**ADDENDUM NO. 1**

RE: Indiana University  
Bloomington BL053 -  
IMU Biddle Hotel –  
Data Upgrades

PROJECT No. 20222853

DATE: May 28, 2024

**1 ELECTRICAL LEGEND**

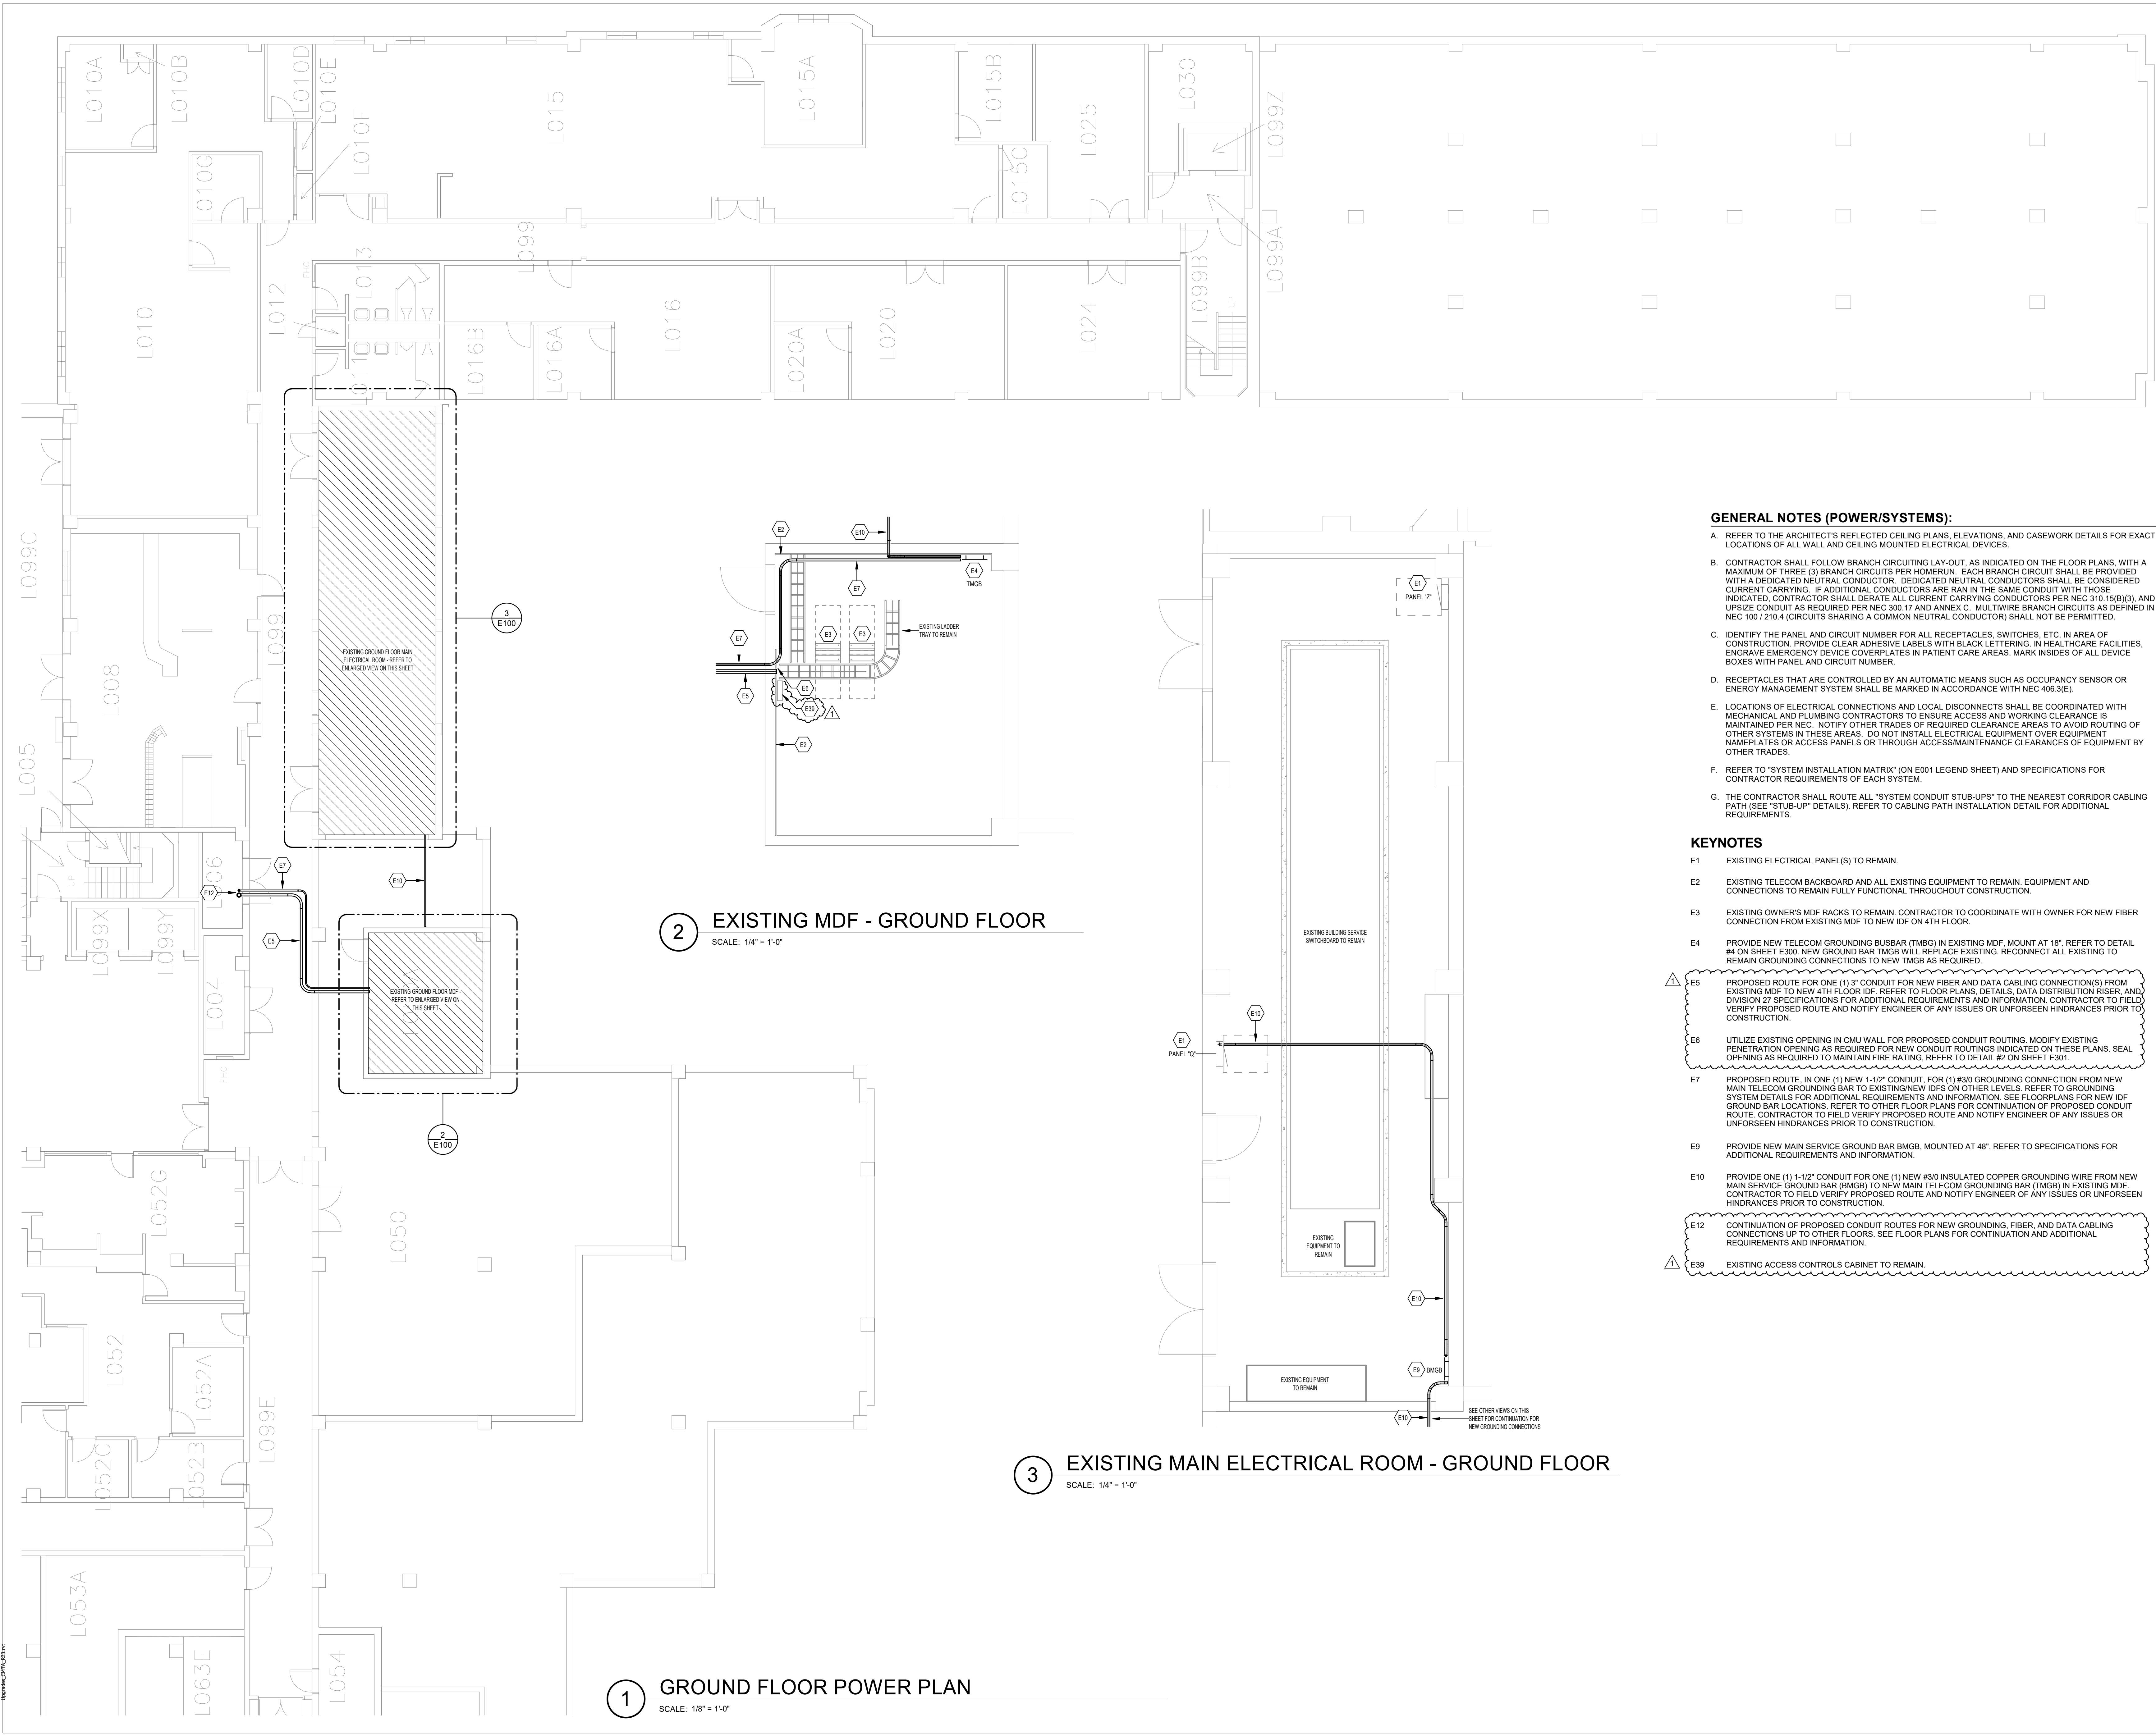
1. Sheet E001 – ELECTRICAL LEGEND
  - a. Clarification to General Notes “C” and “KK”.
  - b. Light fixture schedule updated for color temperature of 3500K for all light fixtures.

**1 GROUND FLOOR POWER PLAN**  
SCALE: 1/8" = 1'-0"

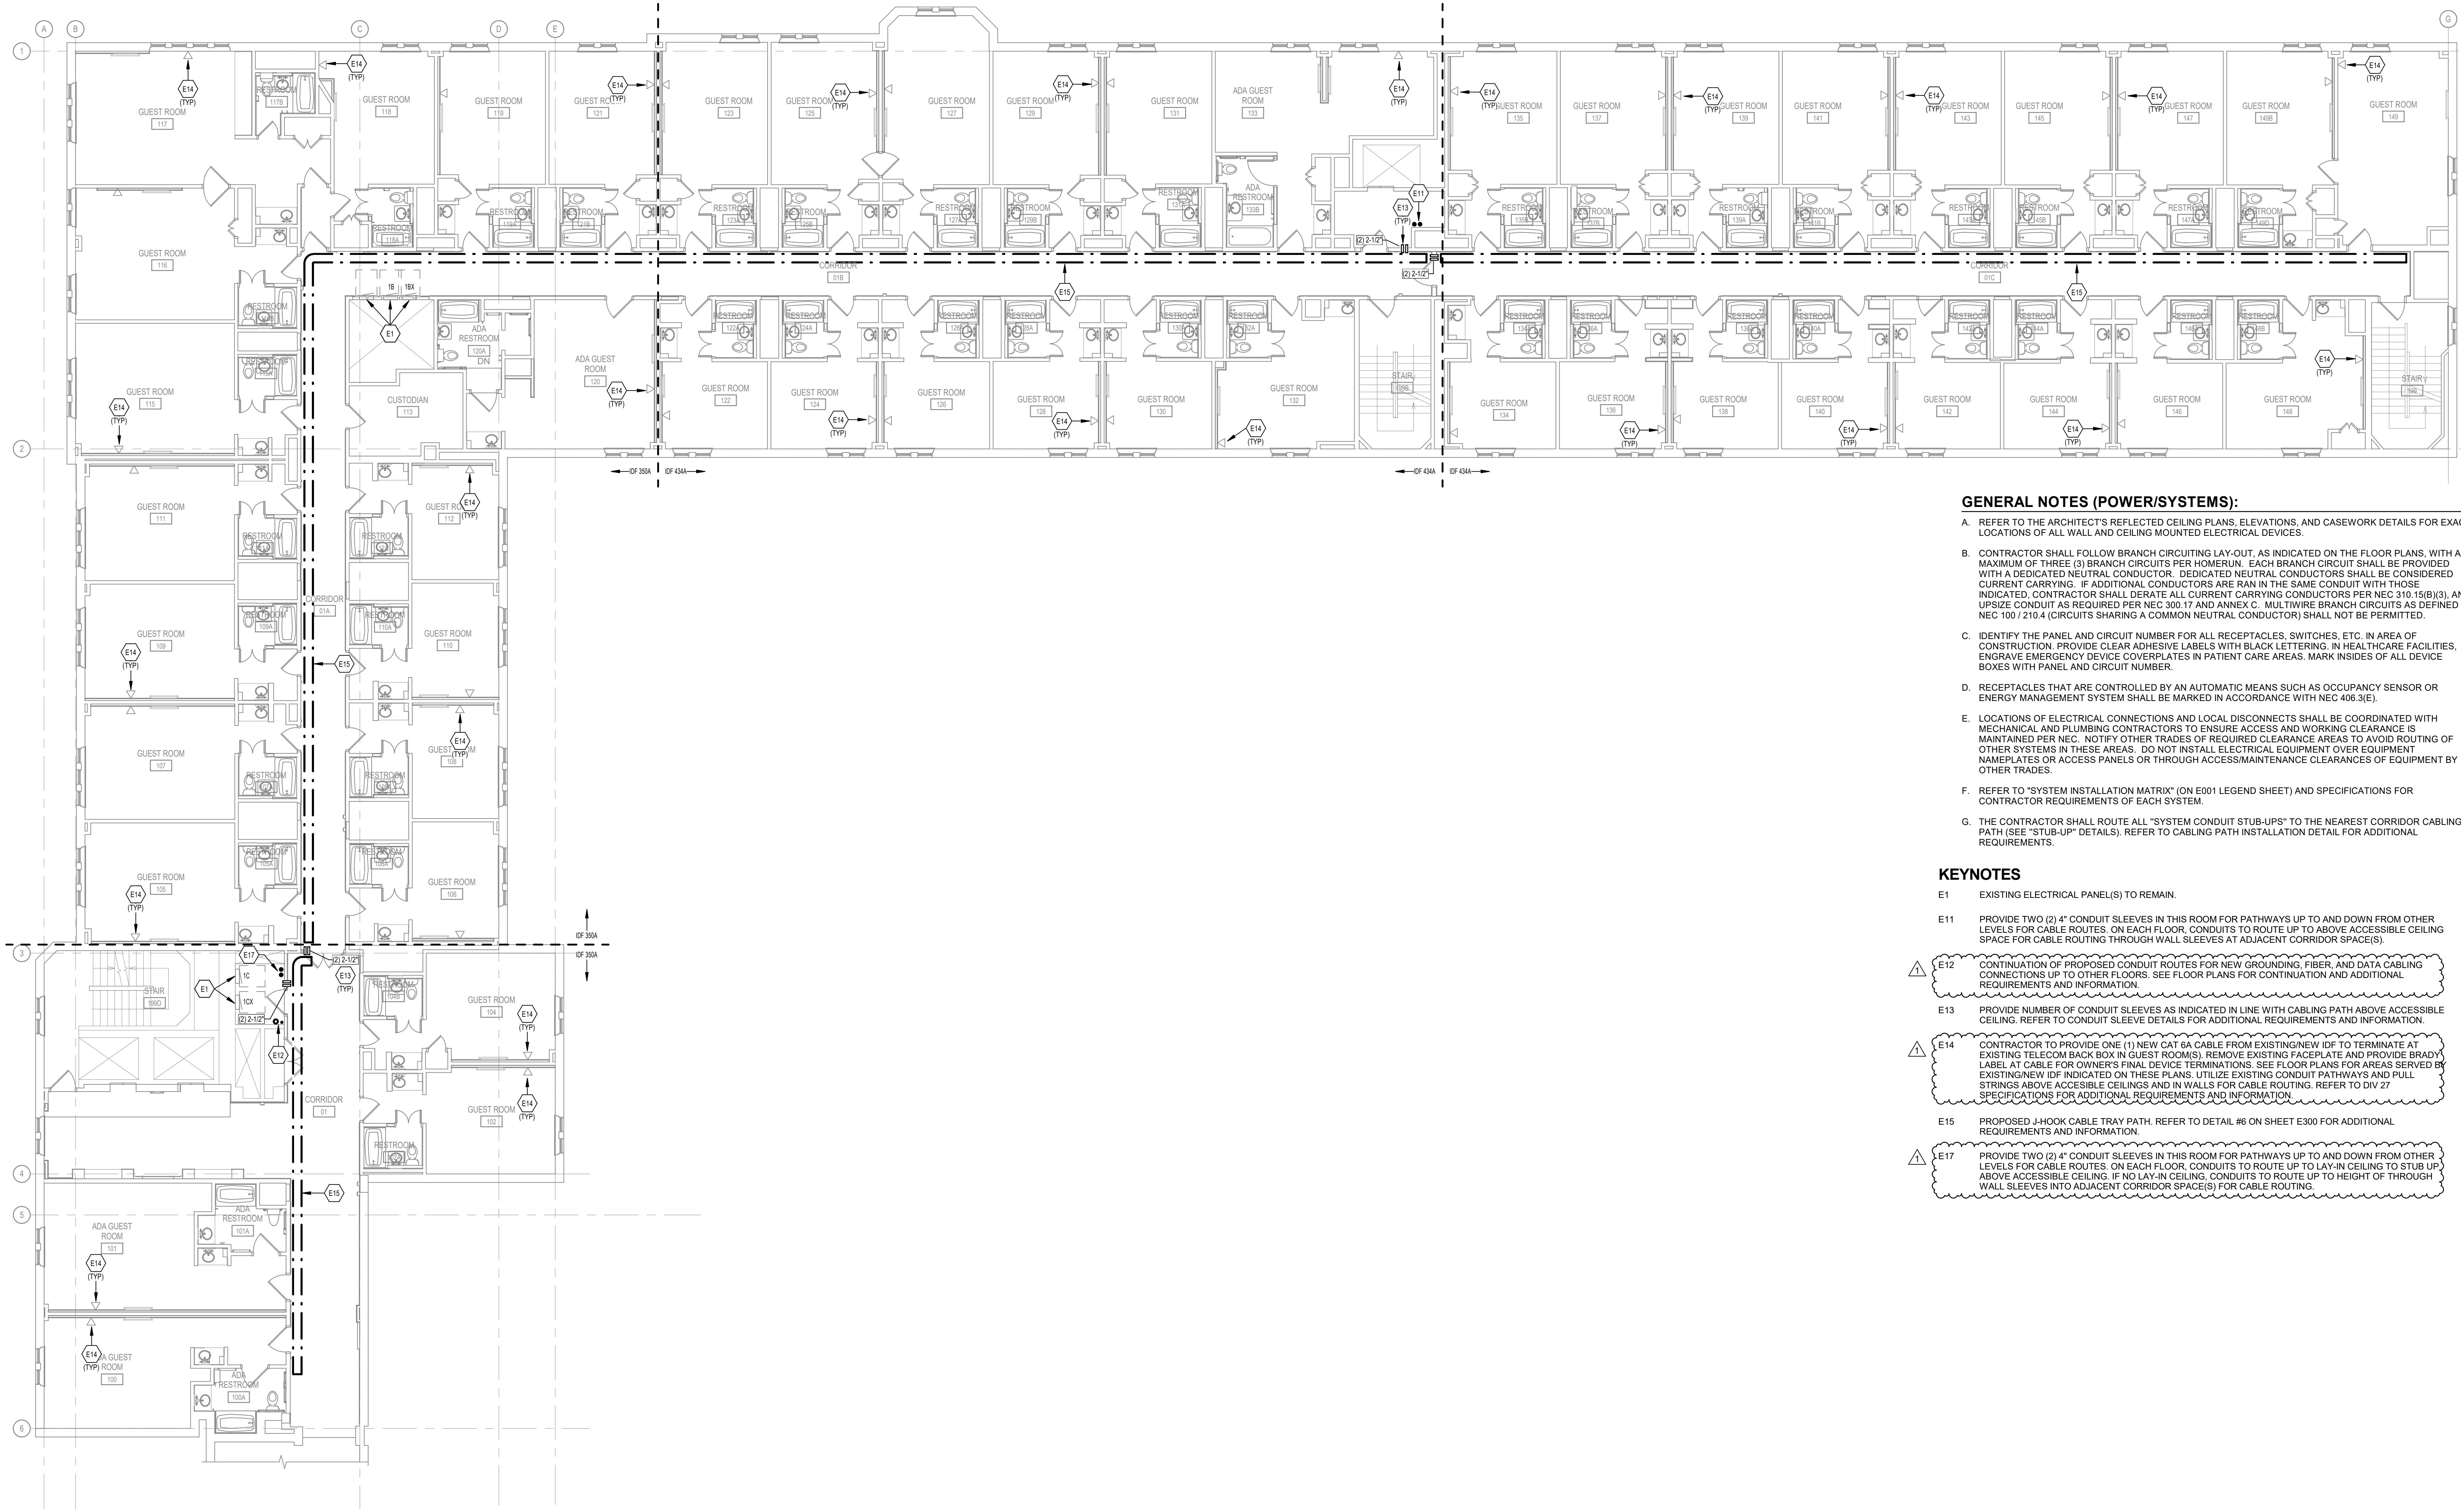
2. Sheet E100 – GROUND FLOOR - INTERCONNECTION PLAN
  - a. Revised tagged notes #E5, #E6, and #E12. Added tagged note #39.
  - b. Existing access controls cabinet indicated on drawings for reference.

- E5 PROPOSED ROUTE FOR ONE (1) 3" CONDUIT FOR NEW FIBER AND DATA CABLING CONNECTION(S) FROM EXISTING MDF TO NEW 4TH FLOOR IDF. REFER TO FLOOR PLANS, DETAILS, DATA DISTRIBUTION RISER, AND DIVISION 27 SPECIFICATIONS FOR ADDITIONAL REQUIREMENTS AND INFORMATION. CONTRACTOR TO FIELD VERIFY PROPOSED ROUTE AND NOTIFY ENGINEER OF ANY ISSUES OR UNFORSEEN HINDRANCES PRIOR TO CONSTRUCTION.

- E6 UTILIZE EXISTING OPENING IN CMU WALL FOR PROPOSED CONDUIT ROUTING. MODIFY EXISTING PENETRATION OPENING AS REQUIRED FOR NEW CONDUIT ROUTINGS INDICATED ON THESE PLANS. SEAL OPENING AS REQUIRED TO MAINTAIN FIRE RATING. REFER TO DETAIL #2 ON SHEET E301.

- E12 CONTINUATION OF PROPOSED CONDUIT ROUTES FOR NEW GROUNDING, FIBER, AND DATA CABLING CONNECTIONS UP TO OTHER FLOORS. SEE FLOOR PLANS FOR CONTINUATION AND ADDITIONAL REQUIREMENTS AND INFORMATION.

- E309 EXISTING ACCESS CONTROLS CABINET TO REMAIN.
